Tuesday, September 13, 2022
Medway Planning and Economic Development Board
155 Village Street
Medway, MA 02053
Meeting Minutes

BOUNDARY LANE SUBDIVISION ENDORSEMENT:

We reviewed the Plans titled "Definitive Subdivision Plan, Boundary Lane, A permanent Private Way, Medway, Massachusetts" dated August 20, 2021 with revisions through August 15, 2022 and compared the Plans against Section VII – Conditions of the Certificate of Action dated July 26, 2022. We have the following comments:

- Email from Peter Bemis requesting a minor field change to the Waterside Run Units
- Plan titled “Existing & Proposed Conditions Exclusive Use Area 3H” dated August 8, 2022.

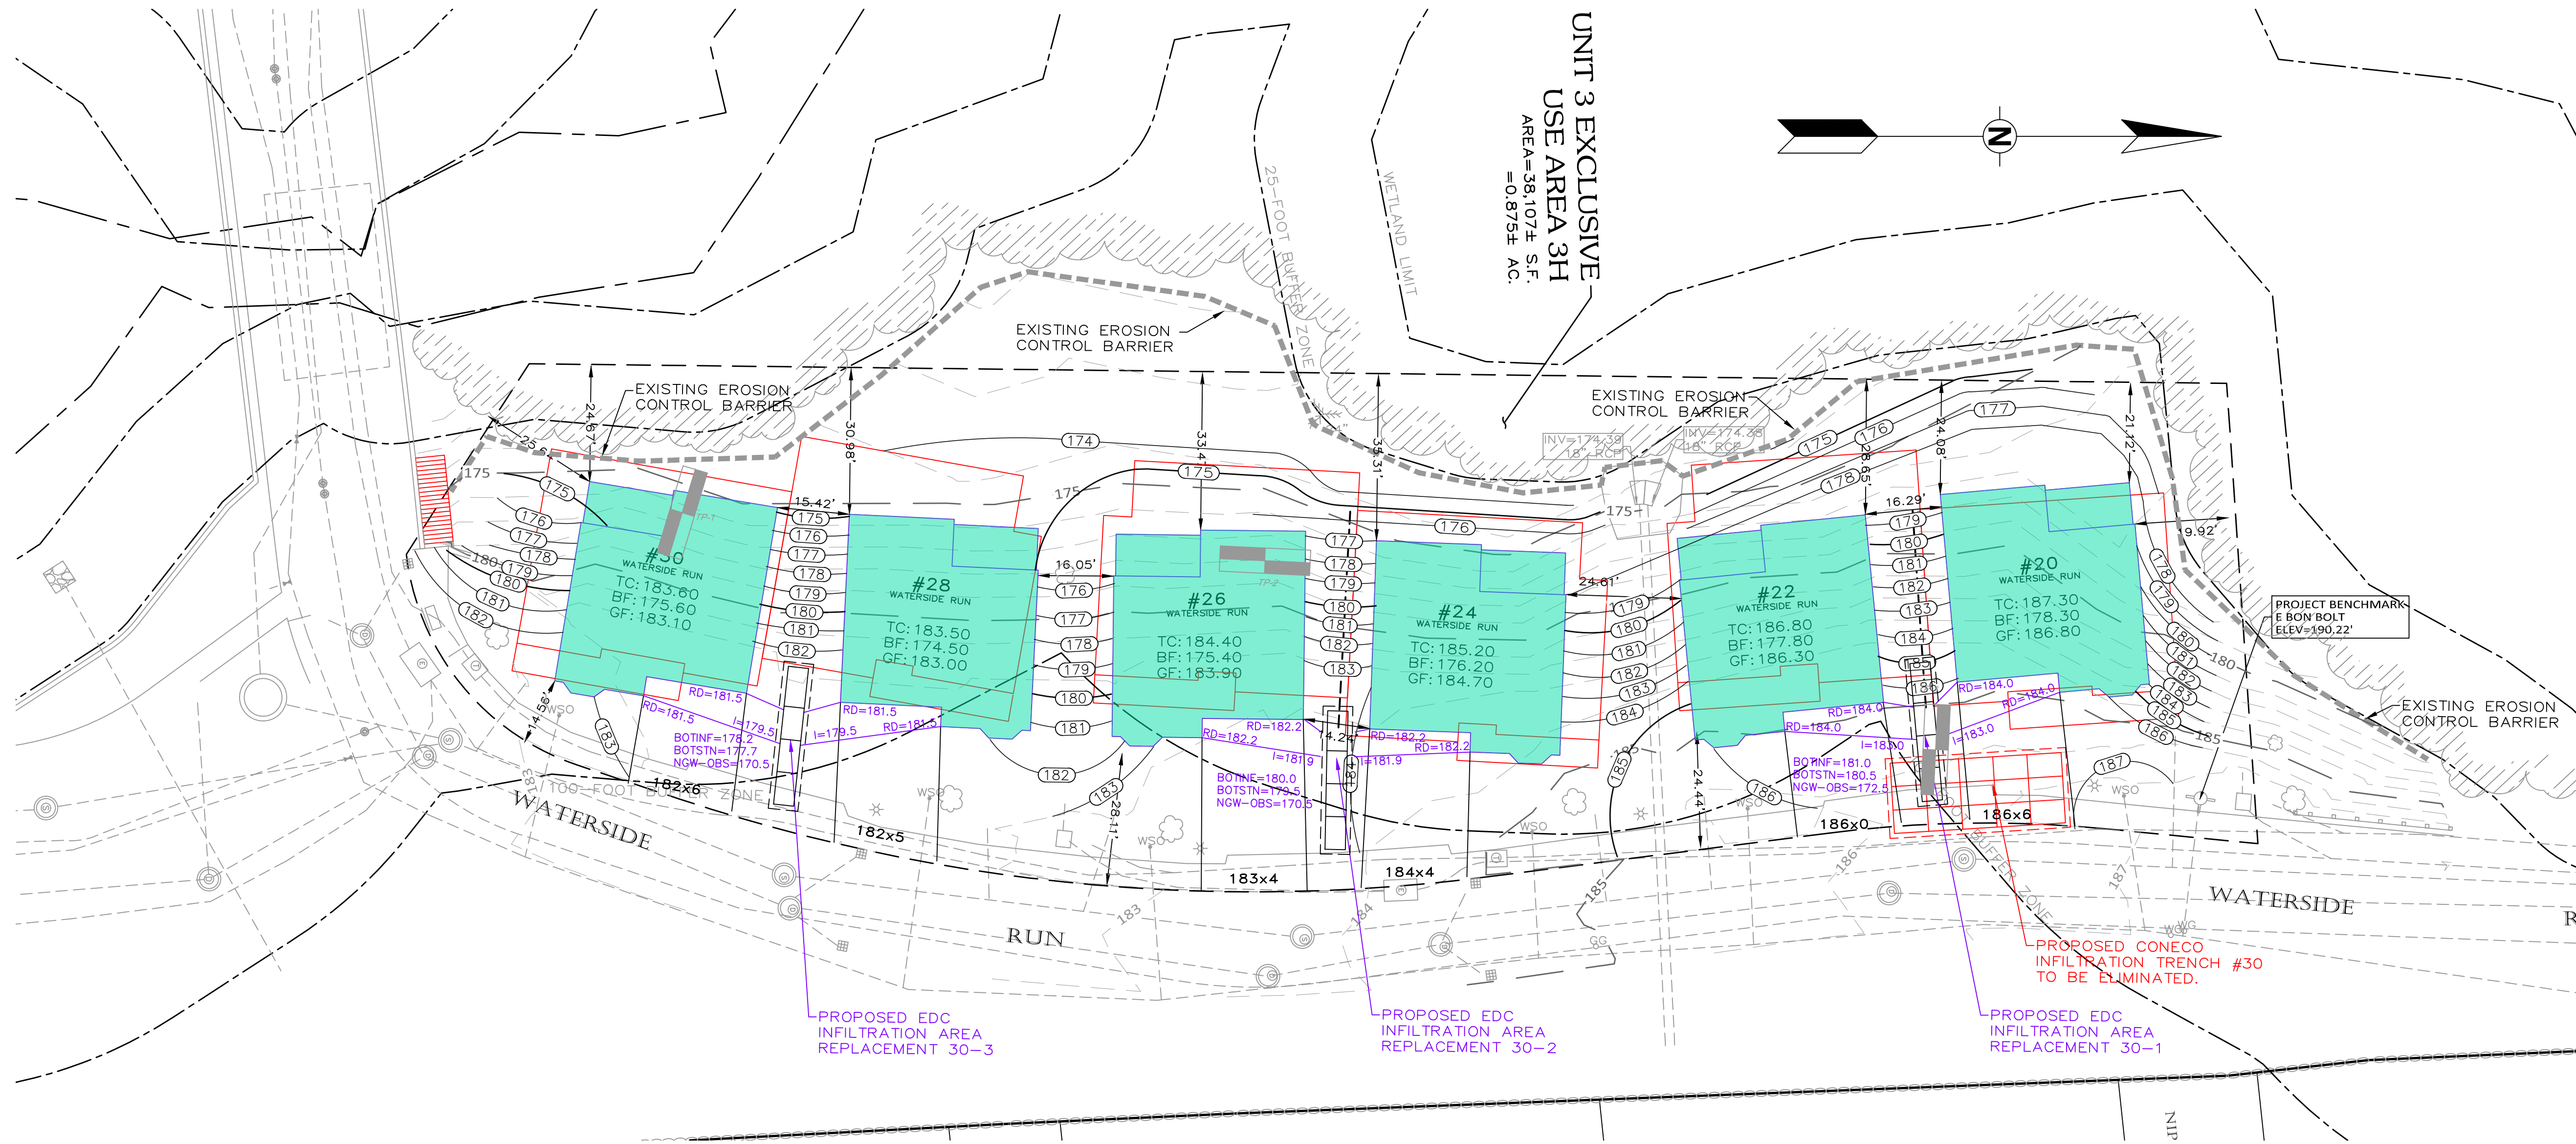
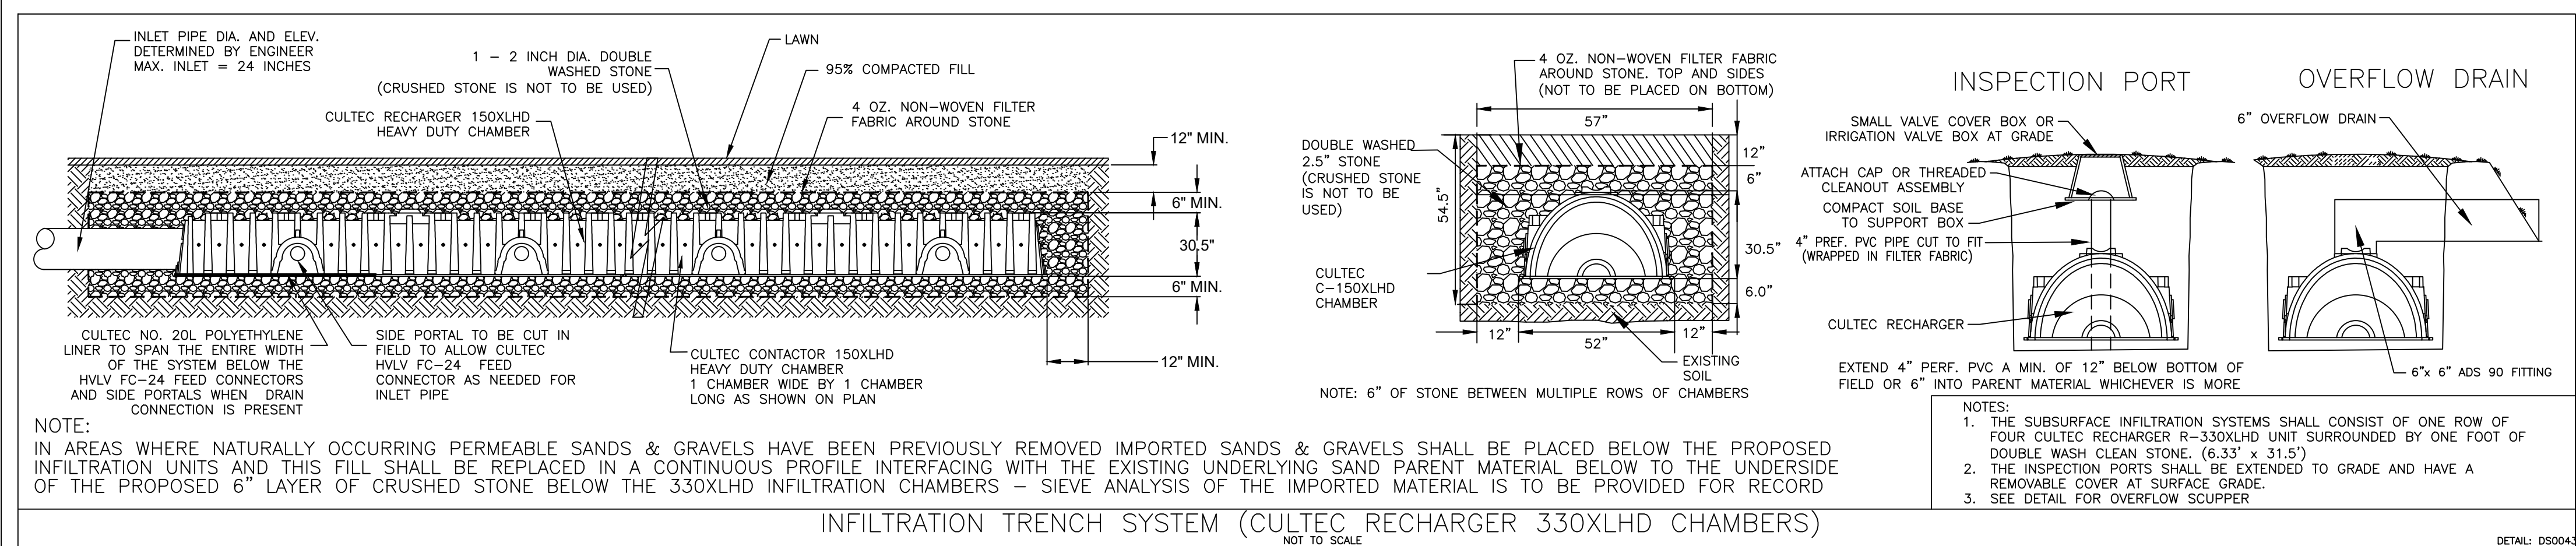
Suzy, Anna & Steve – attached please find Site Plan entitled “Existing & Proposed Conditions Exclusive Use Area 3H” Sheet 1 of 1 dated 8/8/22 and last revised 8/25/22 submitted to you for Minor Field Change Request as it relates to stormwater infiltration at Waterside Run Units 20-30. The approved Coneco Site Plan illustrated Infiltration Trench #30 as a block of 15 Infiltration Units with no further details that was to be located in front of Unit 20 and intended to treat stormwater from Units 20-30, however upon closer inspection we determined that this location in front of Unit 20 was approximately 4-feet higher in elevation than Unit 30 and it was approximately 260-feet away thereby making it nearly impossible to properly convey stormwater from Units 26, 28 and certainly 30 without putting the leaching chambers over 7-feet below grade. We determined that the best course of action was to break the leaching areas into 3 separate zones to be shared by 2 units between their common garage areas and to further support this approach we conducted test pits near each leaching area that were witnessed by Steve Bouley of TetraTech. Having 3 microunits will enable better distribution of stormwater, avoid placing units excessively deep below grade and recall that the total impervious area for these 6 units is approximately 25% less than what was originally approved. Thank you for your assistance in processing this request with the Planning Board and we will plan to attend the 9/13 meeting to present this information.

On a motion made by Jessica Chabot, seconded by Sarah Raposa, the Board voted 5-0 to approve the field change for Salmon Willows, Waterside Run.
